**METROPOLITAN DEVELOPMENT COMMISSION
HEARING EXAMINER**

October 24, 2024

Case Number: 2024-CVR-826 / 2024-CPL-826 (Amended)
Property Address: 1150 East New York Street (approximate address)
Location: Center Township, Council District #13
Petitioner: Ronin Highland Park, LLC, by Jynell D. Berkshire
Current Zoning: D-8

AMENDED SITE PLAN

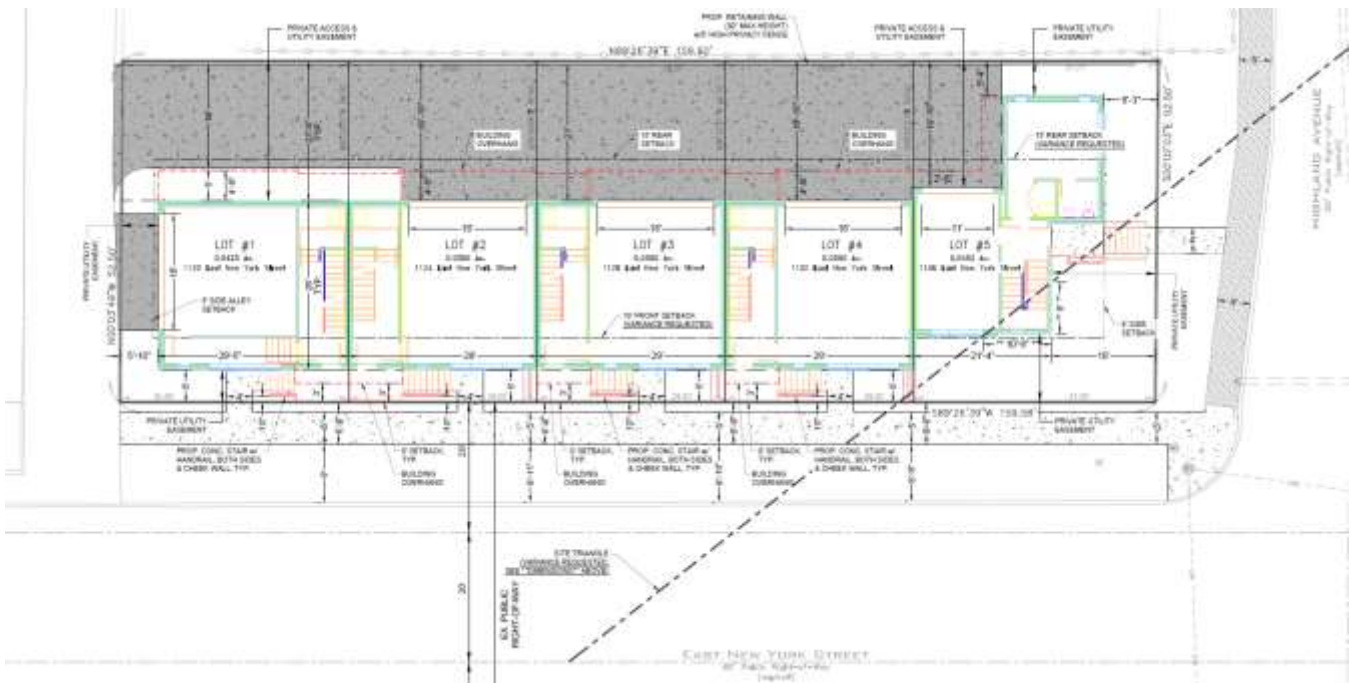
In working with staff, the corner unit was rearranged to face Highland Avenue and provide minimal encroachment into the clear sight triangle. Furthermore, the Department of Public Works provided the petitioner an example of what their version of a clear sight triangle is, Intersection Sight Distance, and the petitioner provided a visual that they would be outside of that area. The new layout pushed the unit further north which created a reduced rear yard setback to allow a reduction of a clear sight triangle encroachment. Staff is now supportive of the clear sight triangle variance request and the reduced rear setback.

PROPOSED SETBACKS CALLED OUT

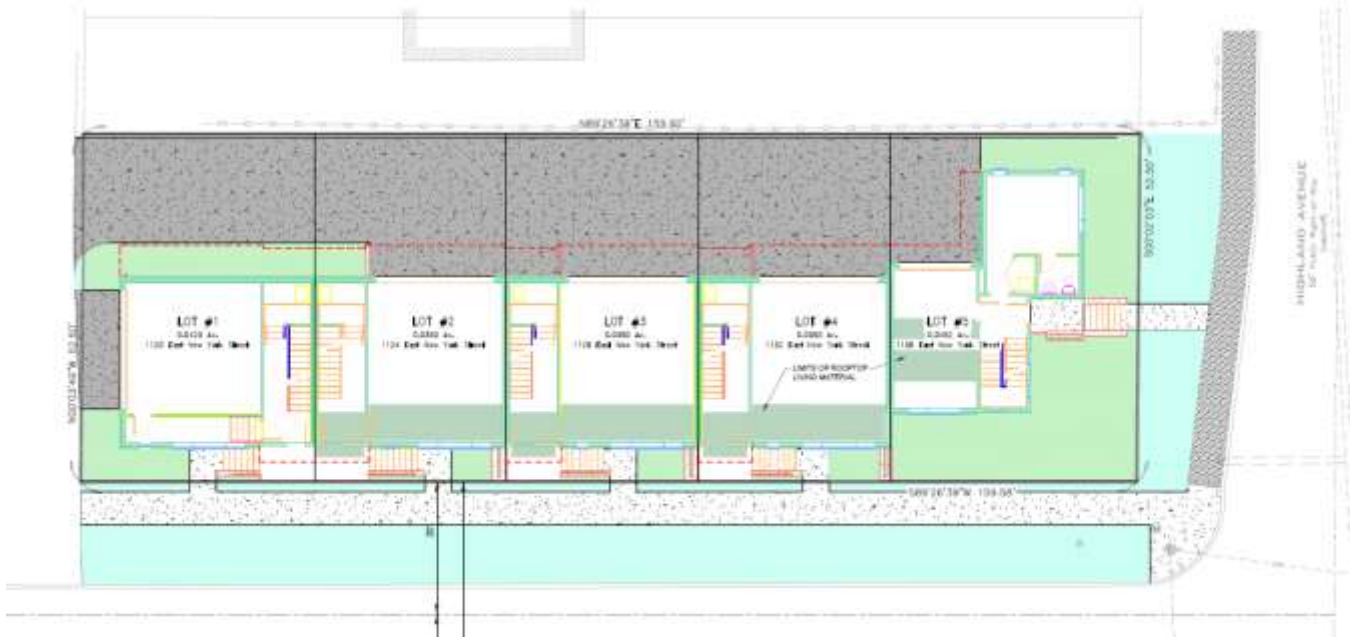
The zero-foot front setback along New York Street is for a staircase in the front yard that provides four units access to the sidewalk. The zero-foot corner side setback along Highland Avenue is also for a staircase for Lot 5 to gain access to the sidewalk. Because the building setback along Highland Avenue will be eight feet and the building setback along New York Street will be five feet, staff determined the staircase encroachment into the corner side yard is supportable.

Lastly, the 50% living material would not be met where the staircase takes up the majority of the front yard, but additional landscaping could be proposed in the right-of-way which staff would support.
